Sheet: /
File: HighImpedanceBuffer.sch

Title: High Impedance Buffer

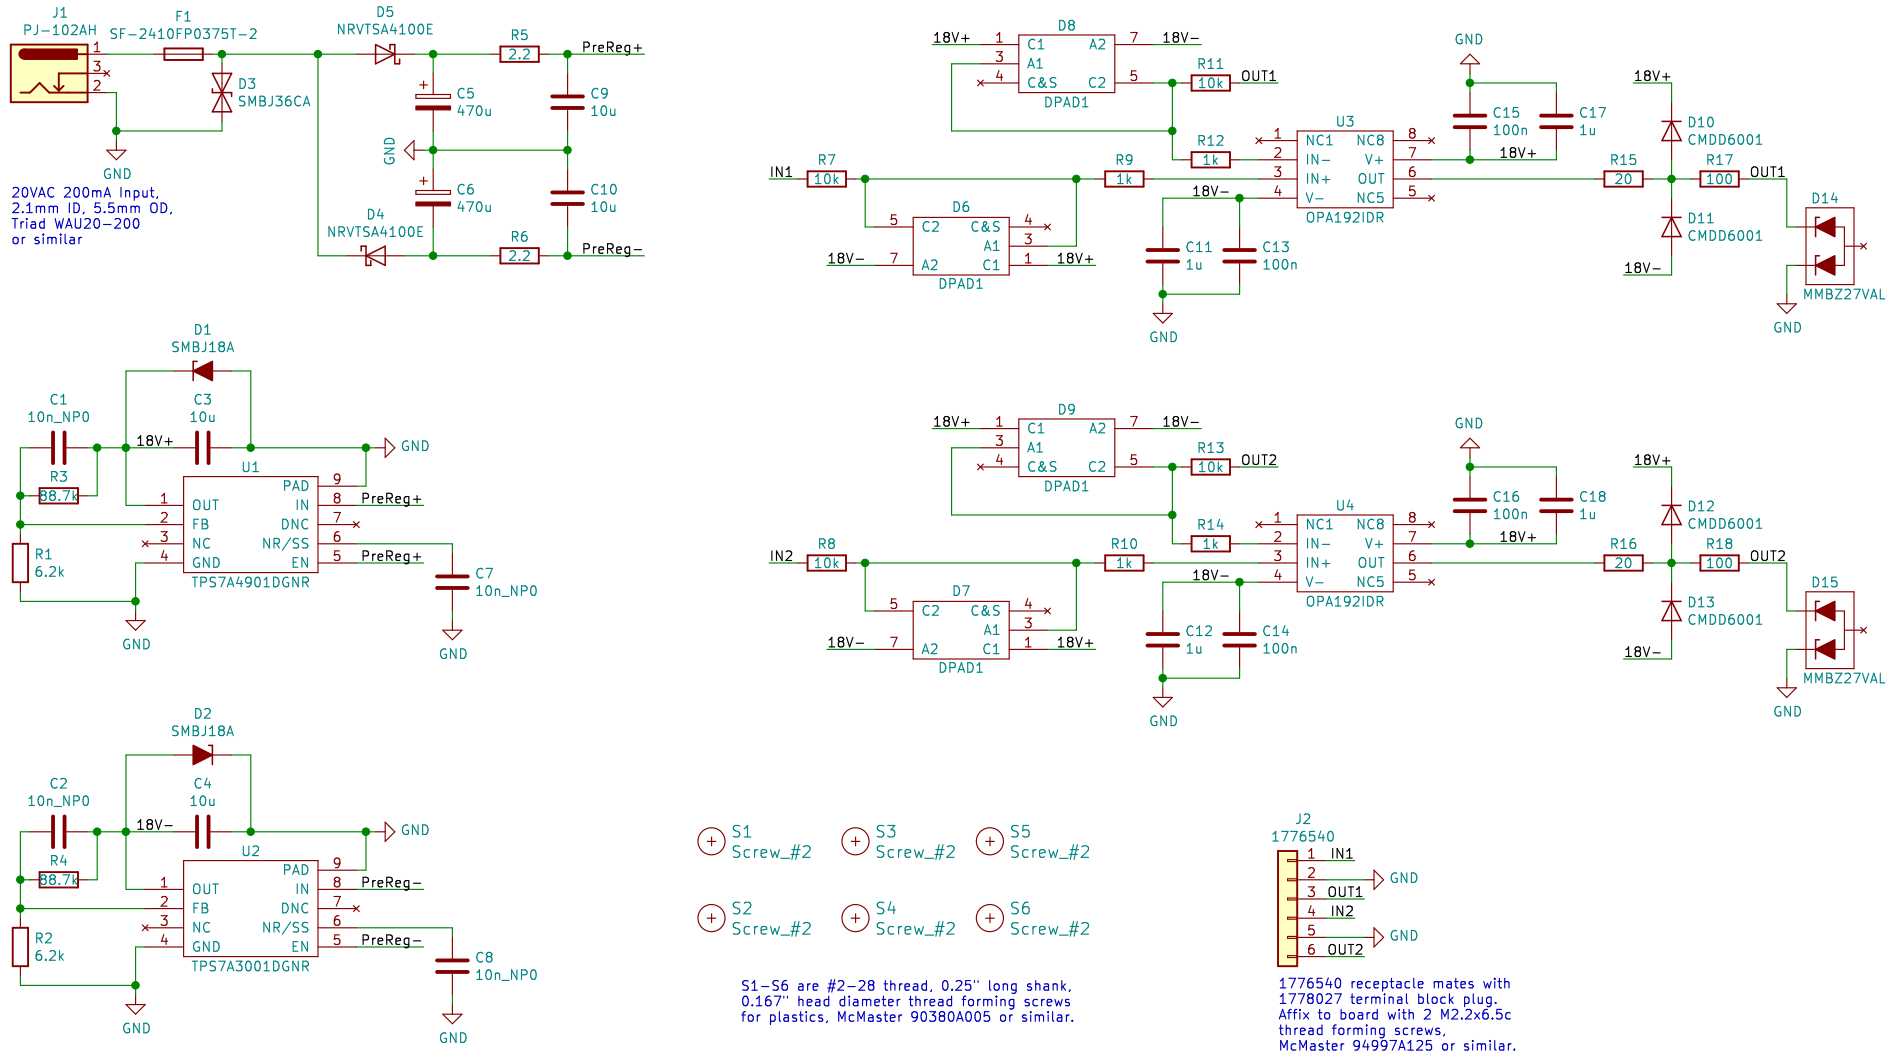
Rev3: Fixing footprint for linear regulator chips. Updating F1 fuse for higher A^2s rating.
Rev2: Mechanical update to board only.
Rev1: Floating all DPAD1 C&S pins as required by datasheet.
